**Letrault and Stuckenduff Forestry Plantation**

**Impact of afforestation and proposed roads on archaeological sites.**

**22 February 2022**

**Figure 3 Site plan included in 21/02164/PNWAY showing proposed road route and impact on archaeological sites identified by GUARD.**

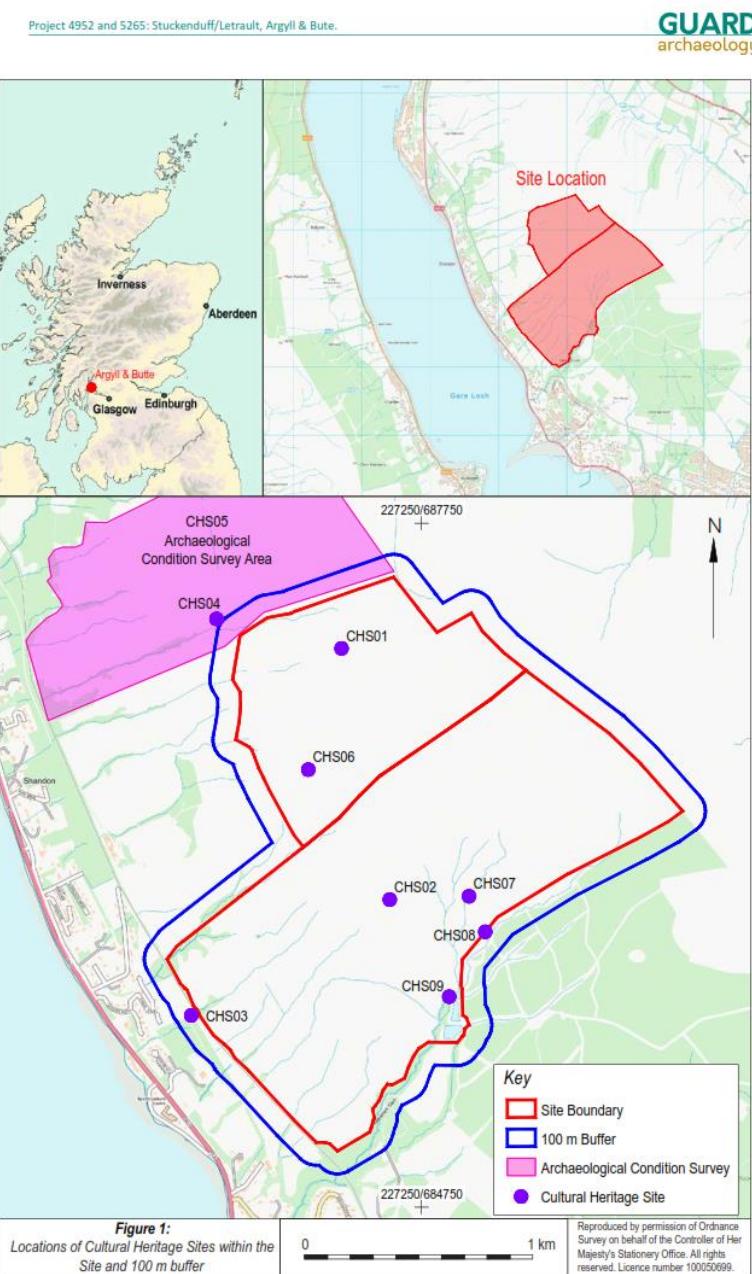
Scottish Woodlands currently have a live planning notification for new roads 21/02614/PNWAY (**Figure 3**). R&S CC have commented on this proposal (submitted to Argyll and Bute Council and Scottish Woodlands on 5 January 2022 but still not uploaded on the planning portal at 22/2/22) and expressed concern that archaeological sites recorded by GUARD will be affected / damaged / destroyed by the proposed road route. No mitigation measures to ensure preservation of the archaeological sites by record has been provided.

The proposed route will have an adverse impact sites 1 / 6 (if they are the same site), 2, 4 and 6 identified on Figure 2. It is highly likely the hut(s) at Site 1 / 6 and the limekiln site 4 will be destroyed.

Figure 1 GUARD survey showing archaeological sites.

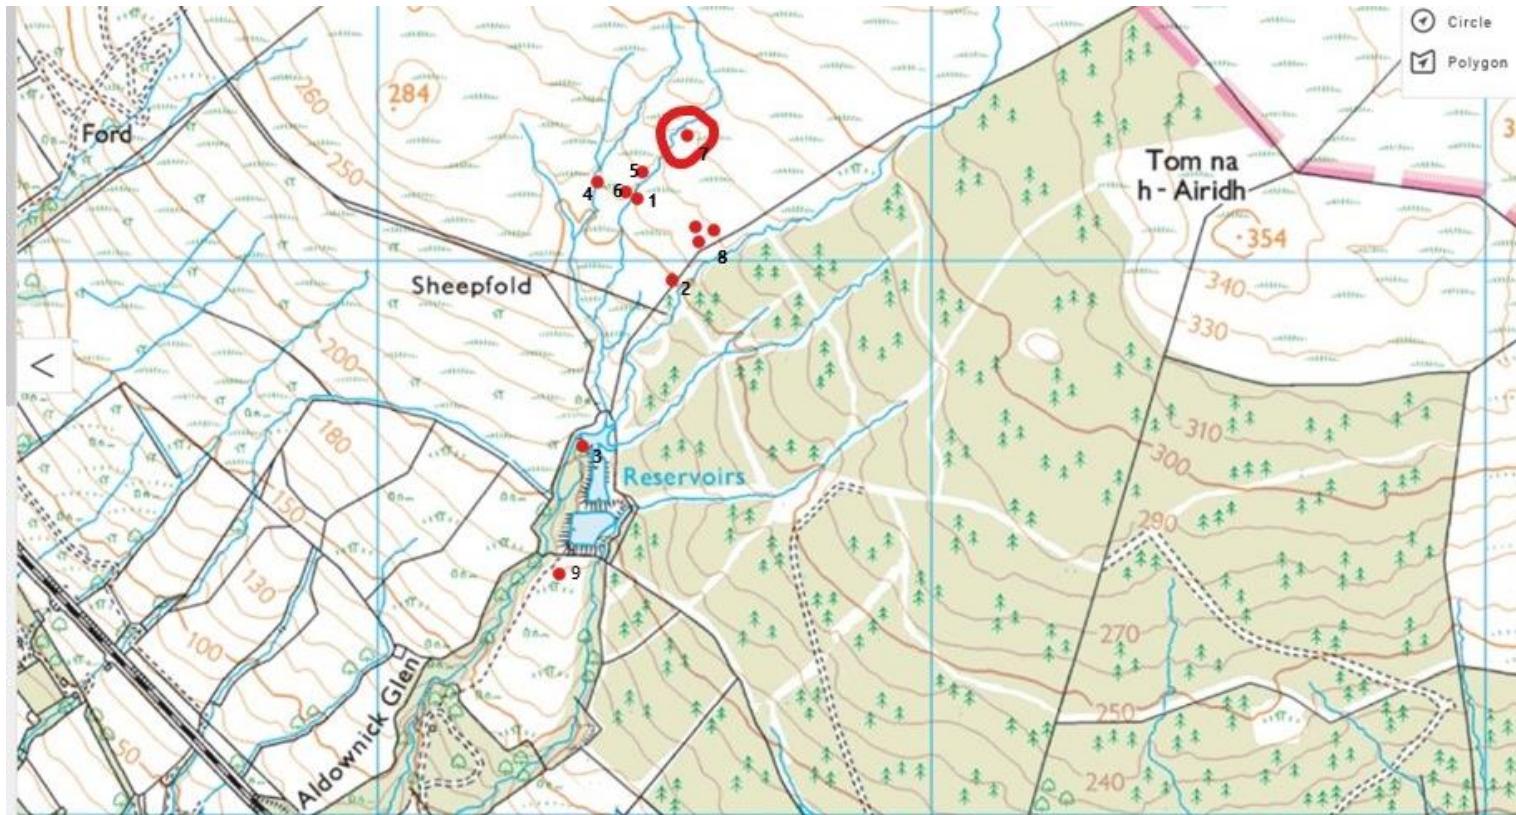
GUARD identified a total of 9 archaeological sites across the whole land parcel. Subsequent informal archaeological work in a small portion of the planting area by the North Clyde Archaeological Society (NCAS) has identified a further four (seven) archaeological sites that were not recorded by GUARD in the eastern part of the scheme. This is the only part of the planting area that NCAS has surveyed. (see **Figure 2**)

The bomb crater (Site 9 on Figure 2) was reported to Scottish Woodlands by Rhu and Shandon Community Council (R&S CC) at the ‘consultation’ stage of the forestry scheme as it should, according to the methodology given, have been noted by the GUARD survey. R&S CC, who have in-house professional archaeological advice, expressed concerns at that time that the archaeological survey had not provided adequate assessment of the plantation site. A more than 100% increase in the number of archaeological sites in such a small portion of the area indicates that the reservations expressed by R&S CC are justified.

**Figure 2 OS extract showing archaeological sites recorded by GUARD and by North Clyde Archaeological Society.**

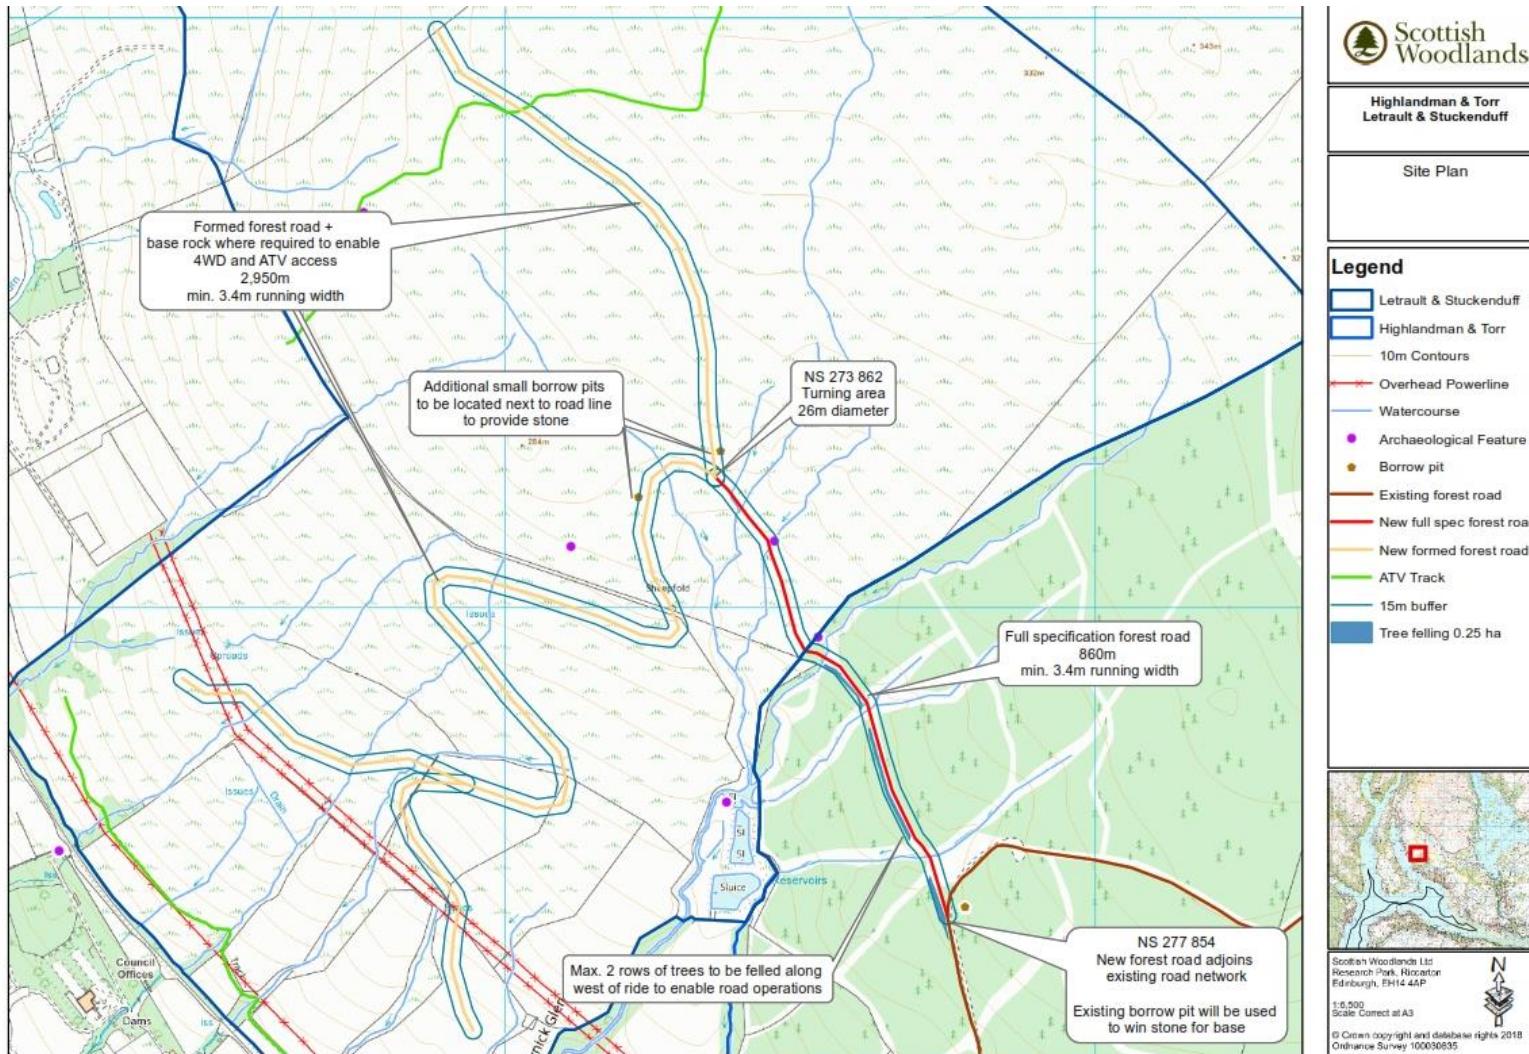
The bomb crater has now been recorded by NCAS, along with the reservoirs. Dykes and sheepfold / enclosure are still unrecorded.

Given that NCAS recorded archaeological sites that were missed by the GUARD survey, including a limekiln, R&S CC request that the area is subjected to a further archaeological survey to identify and flag all archaeological sites in the forestry area prior to any development being permitted to proceed.
